**ADDENDUM
NO. 1**

March 3, 2021

Scott County School District 1 – Austin Elementary Additions & Renovations and HS Pool Renovation
Austin, IN 47102

ADDENDUM NO. ONE

DETAIL 209 - SYNTHETIC PAD FOR UNDER HIGH TRAFFIC AREAS
NOT TO SCALE

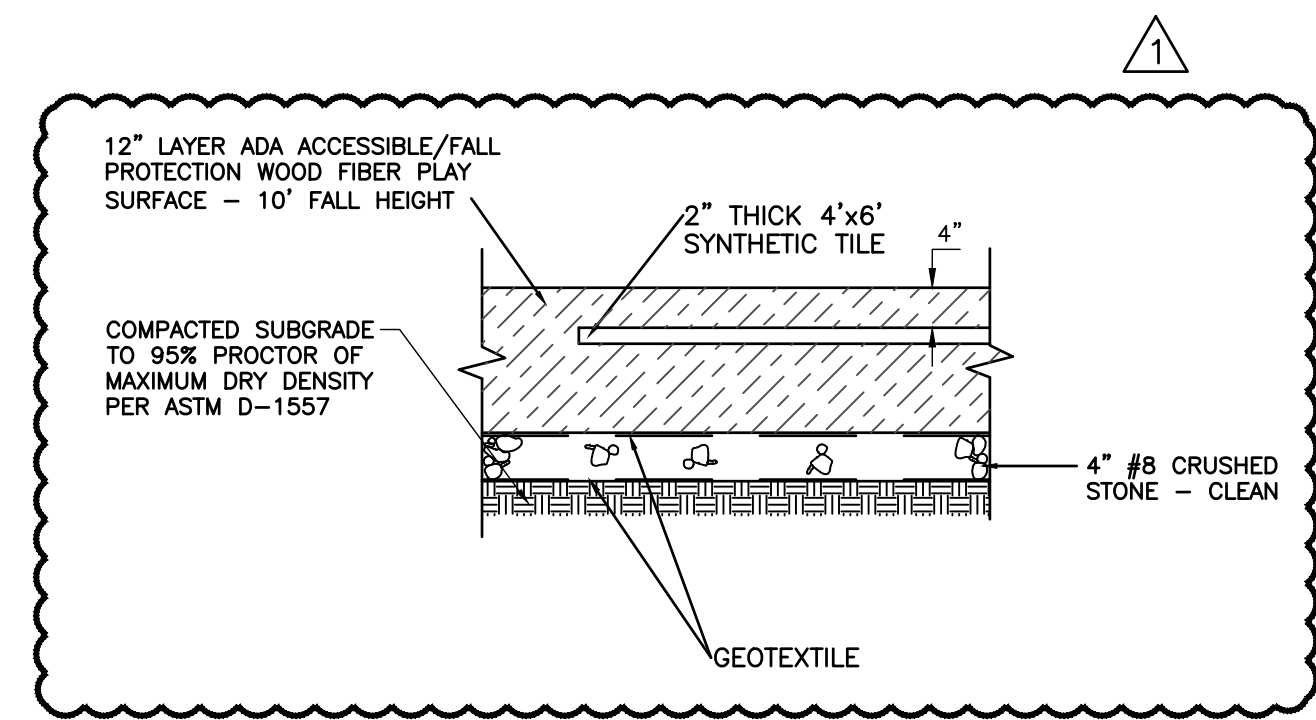
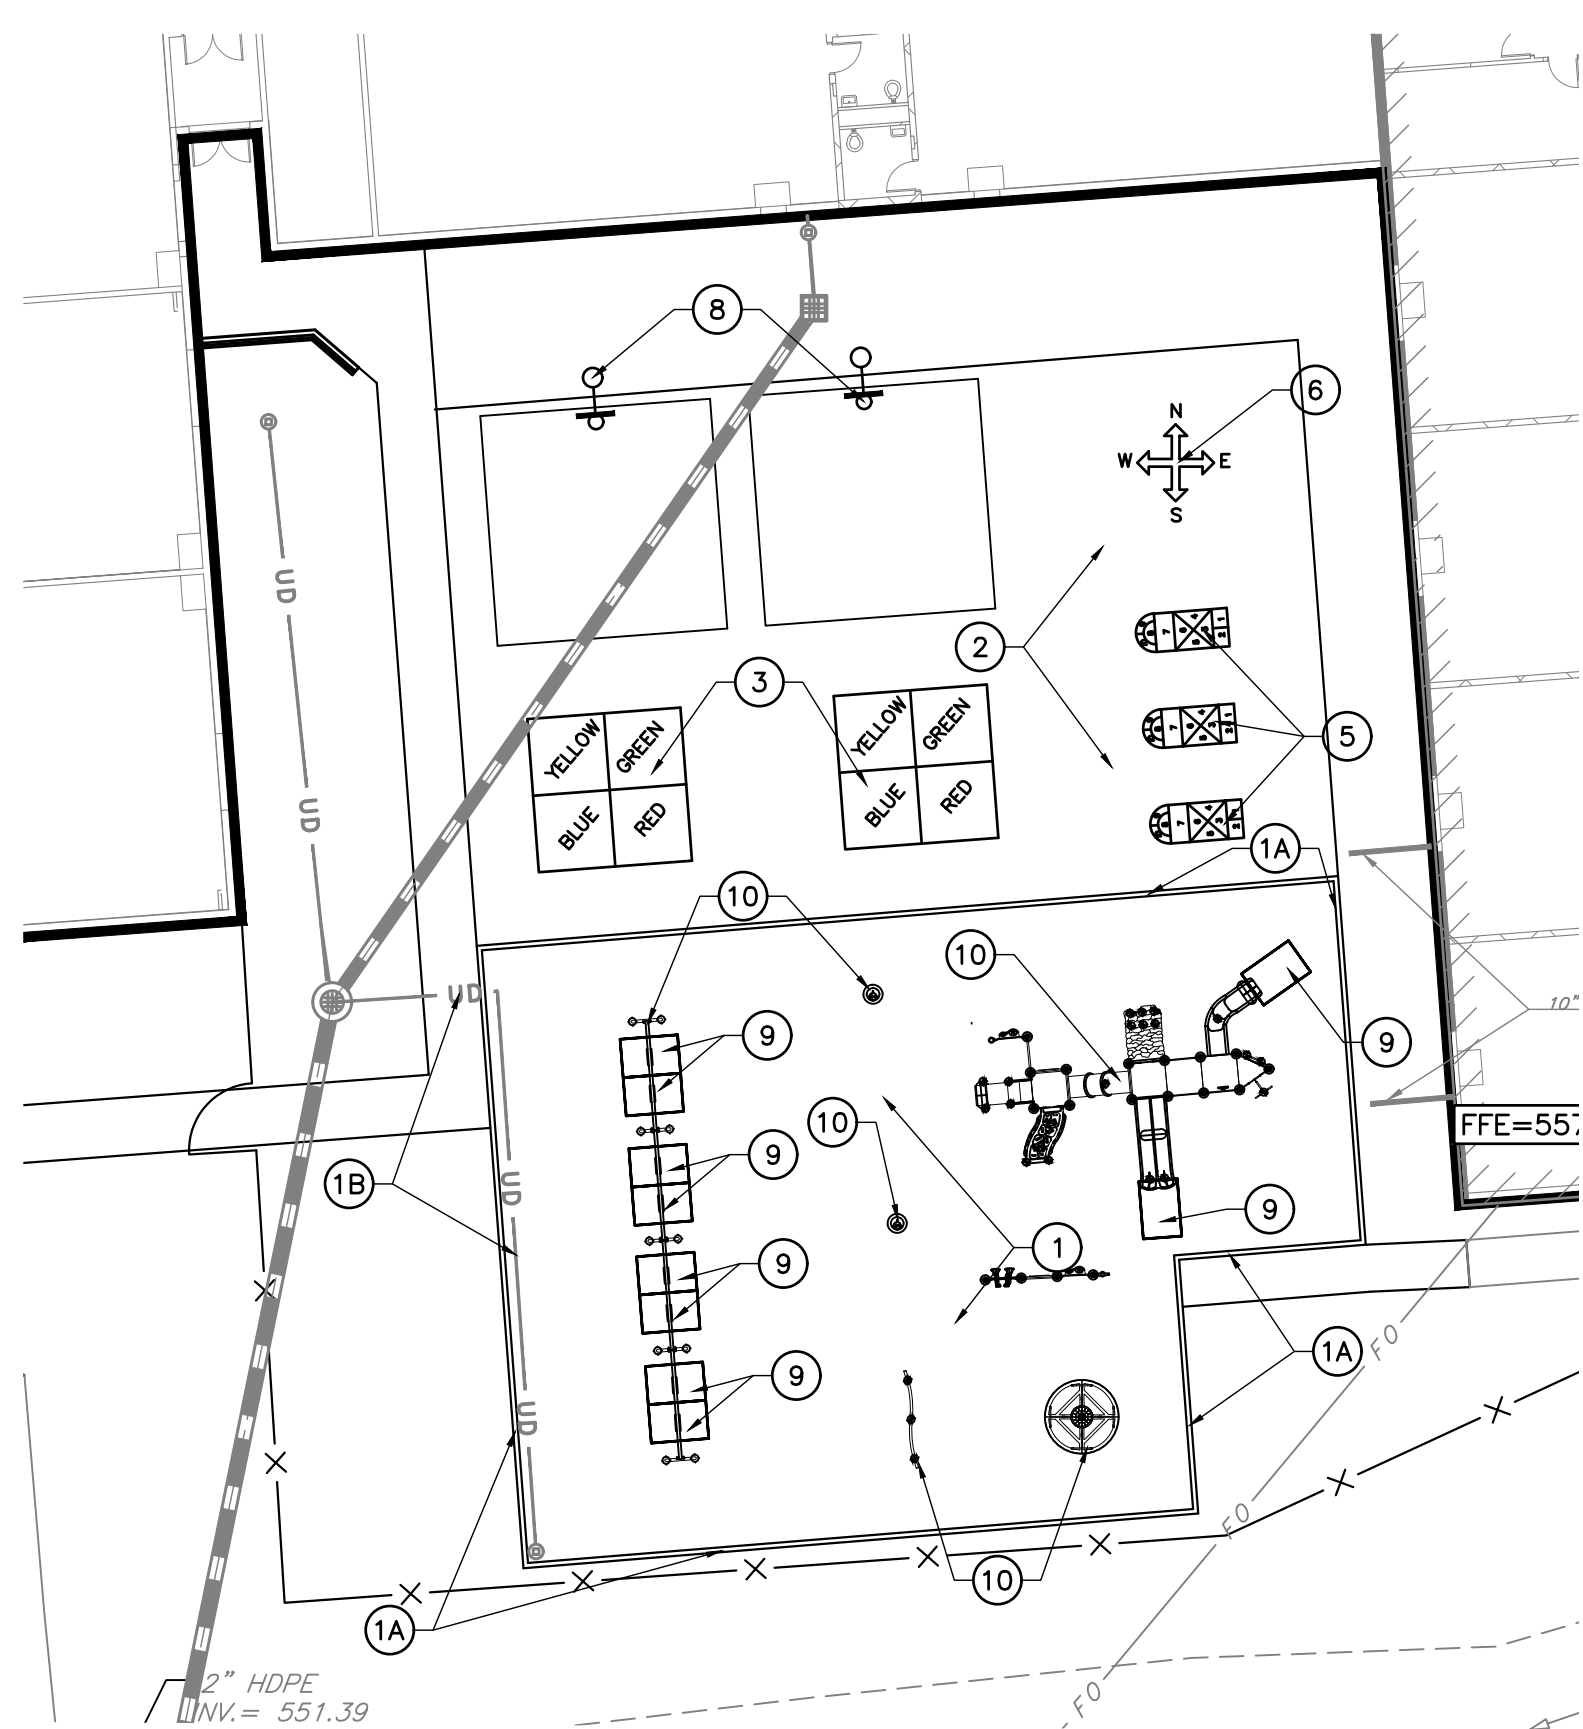
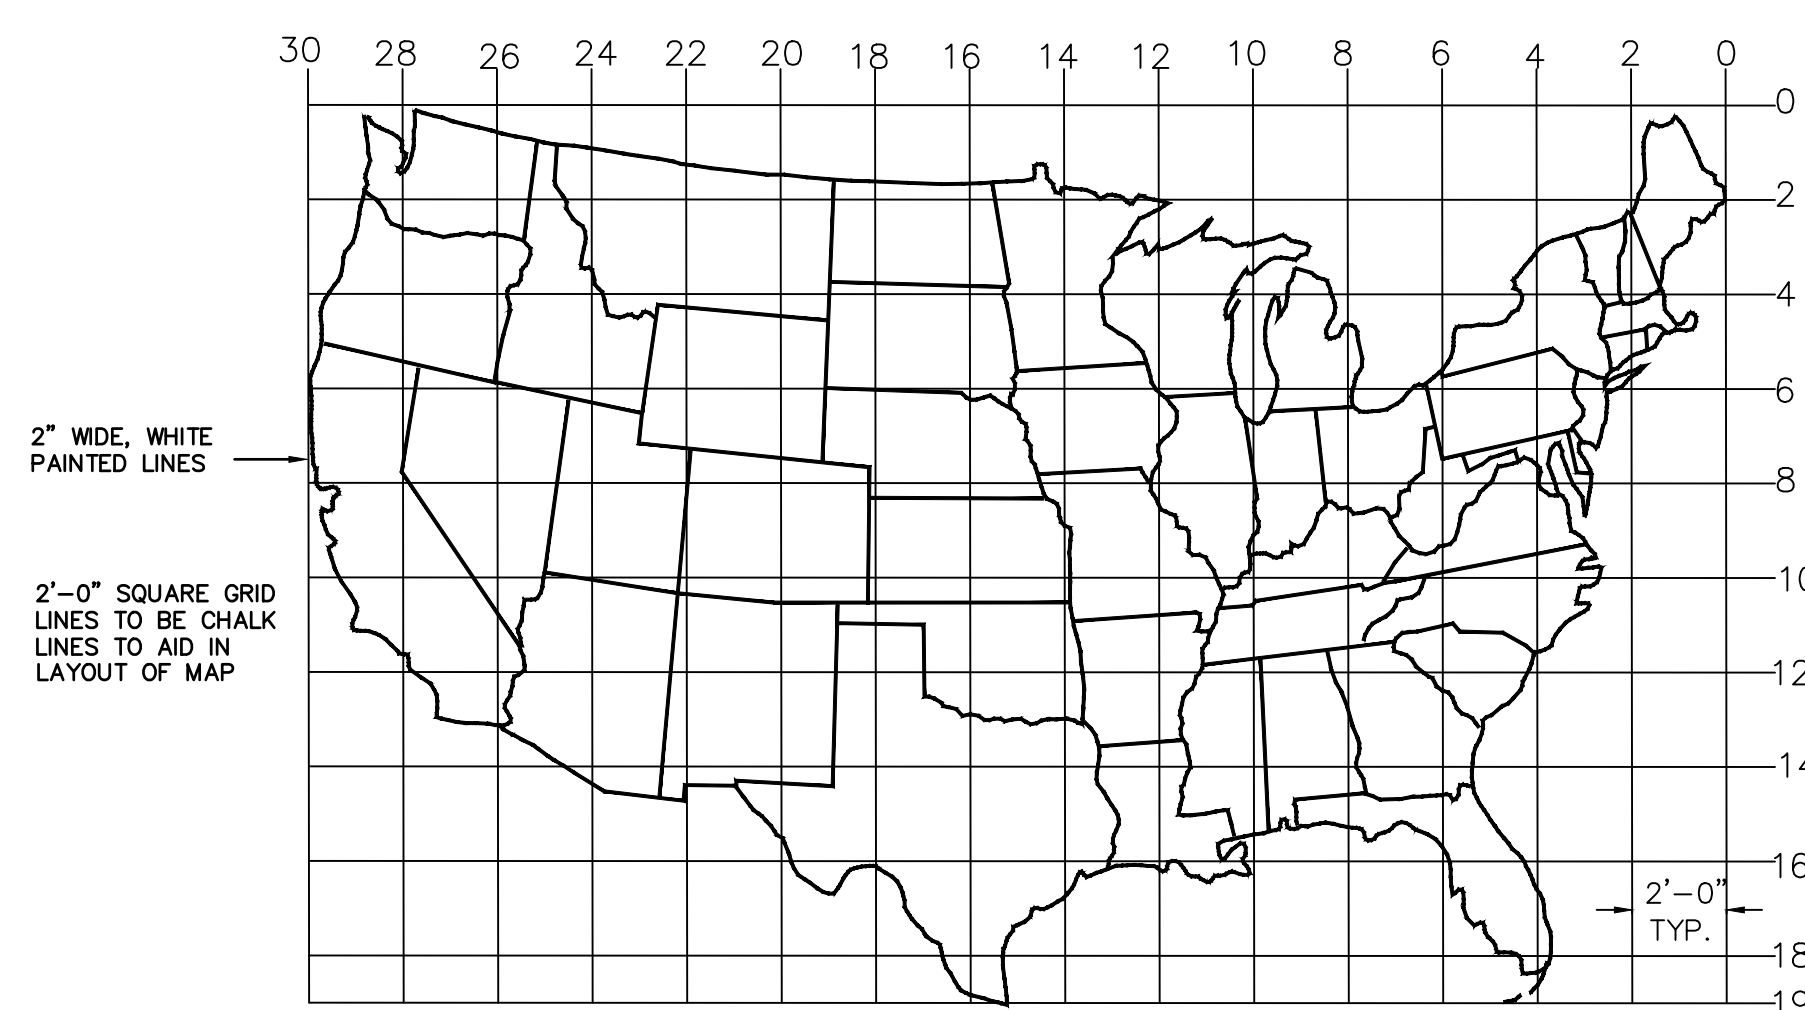
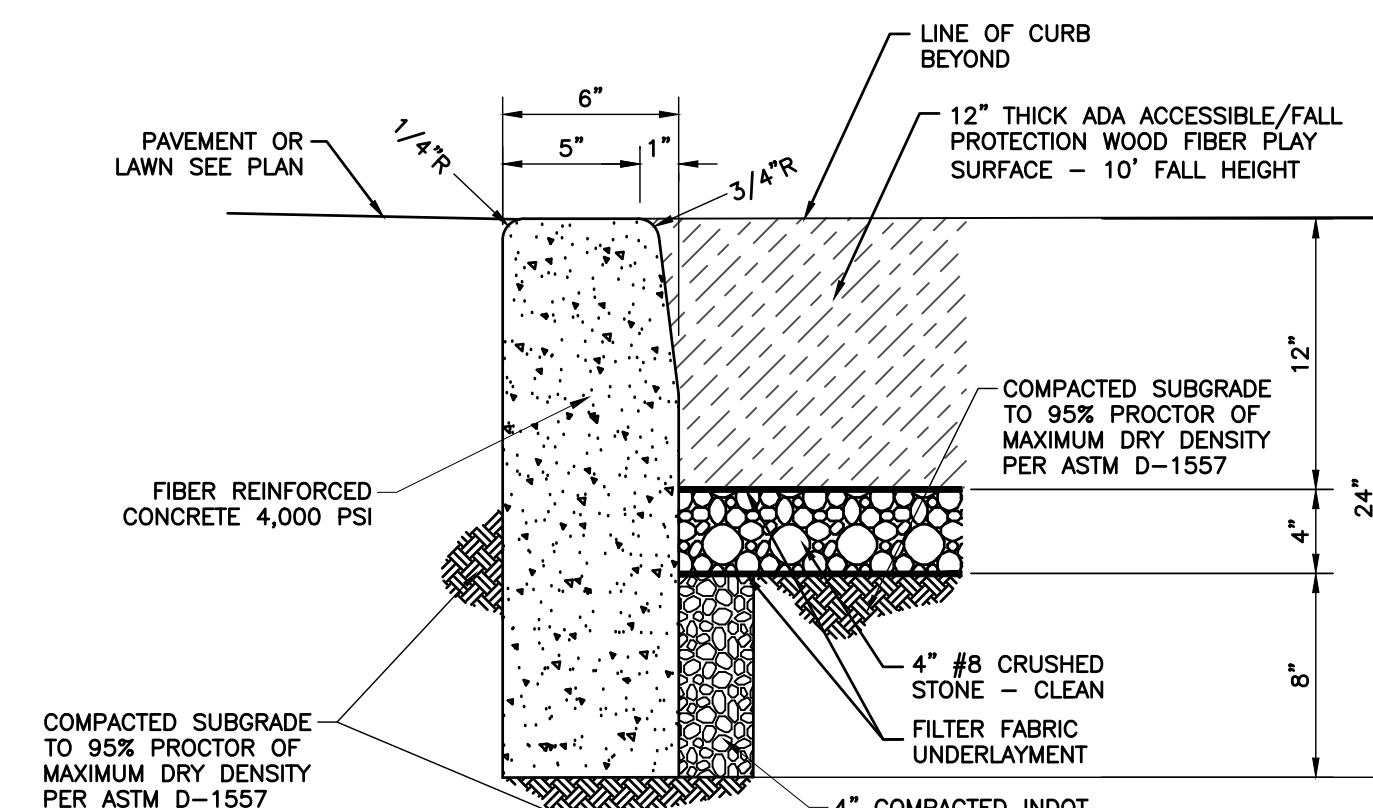
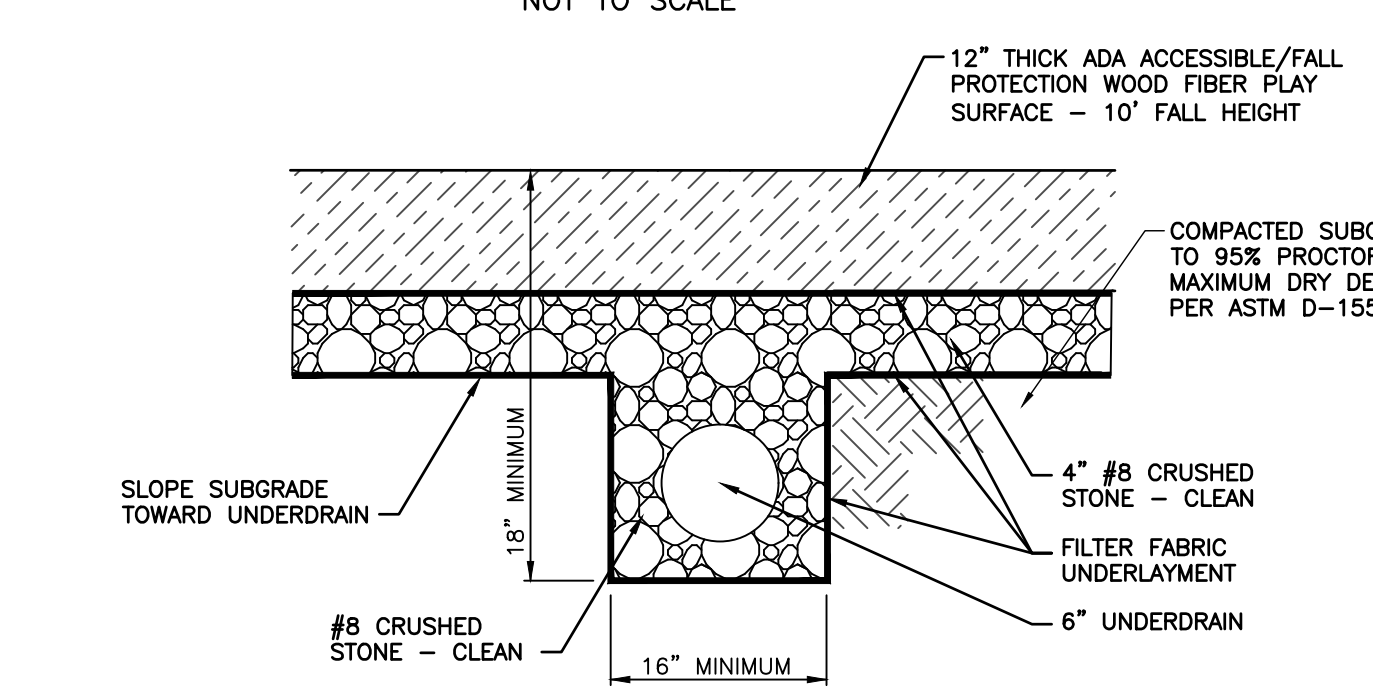
Delete Detail 201 complete.

Revise Plan Key Note 9, indicating size and basis of design for synthetic playground pads.

Revised Detail 209, indicating installation depth of synthetic playground pads within Wood Fiber Play Surface.
